Work Order ID 160673

Item ID: D206-642-441 Accept ***N900040100*** Setup Start ***NS1***
Revision ID: Stop ***NS2***
Item Name: Replacement Skidtube, High Gear with Standard Wearplates Fits LH or RH
Start Date: 5/4/2017 Start Qty: 1.00 ***1*** Cust Item ID:
Required Date: 5/16/2017 Req'd Qty: 1.00 ***1*** Customer:
Reference: SCHEDULED/C

DRAWING NO. D2650	TITLE 206/407 SKIDTUBE ASSEMBLIES	REV. F	DART AEROSPACE LTD ENGINEERING ORDER		D.E.O. NO. D2650-F-1	SHEET NO. SHEET 1 OF 1	SCALE NTS
DRAWN <i>[Signature]</i>	CHECKED <i>A.P.</i>	MFG. APPR. <i>[Signature]</i>	APPROVED <i>[Signature]</i>		DE APPR. <i>[Signature]</i>		
DATE 12.10.12	DATE 12.10.22	DATE 12.10.22	DATE 12.10.22		DATE 12.10.22

CHANGE C'BORED WELDED CROSSBOLT SPACERS TO SWAGED SPACERS

DETAIL G
FOR Ø0.375 HOLES ONLY
FOR HOLES THAT ARE CURRENTLY C'BORED ONLY
NOT TO SCALE

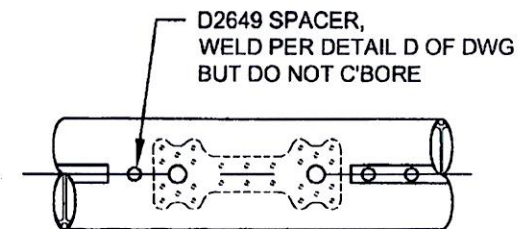
ADD DETAIL G BELOW, WHICH IS THE SAME SECTION VIEW AS DETAIL D OF DWG.

AFTER DRILLING AND BENDING ASSEMBLY
PERFORM THE FOLLOWING FOR Ø0.375 HOLES THAT ARE
CURRENTLY C'BORED:

1. INSERT D4720-1 SPACER, 16 PL (-1) OR 17 PL (-3)
OR 19 PL (-5) OR 23 PL (-7)
2. SWAGE TO Ø0.313 X 0.75 DP PER QSI 002
3. TRIM / GRIND FLUSH PER QSI 002

DETAIL B
AMENDMENT TO DETAIL B
NOT TO SCALE

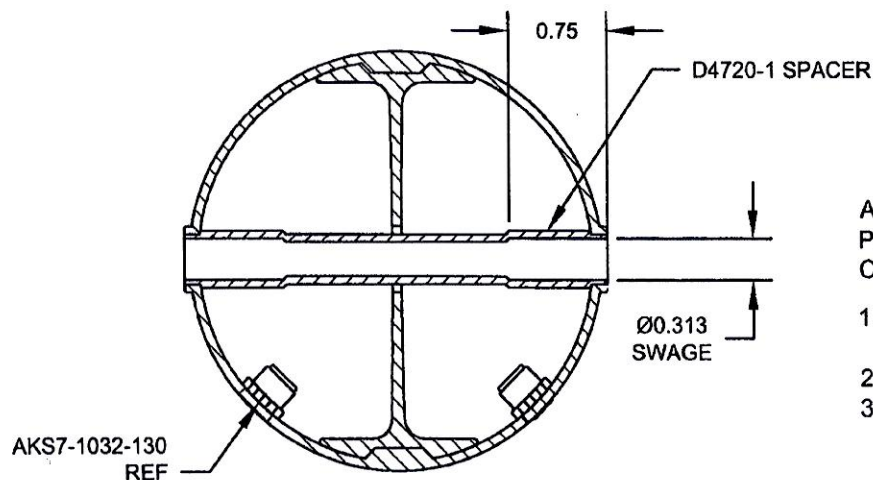
C'BORED HOLES ARE **NOW SWAGED** PER DETAIL G BELOW. FOR THE Ø0.375 HOLE THAT IS NOT C'BORED, WELD PER DETAIL D OF DWG (SEE AMENDED DETAIL B FOR REFERENCE).
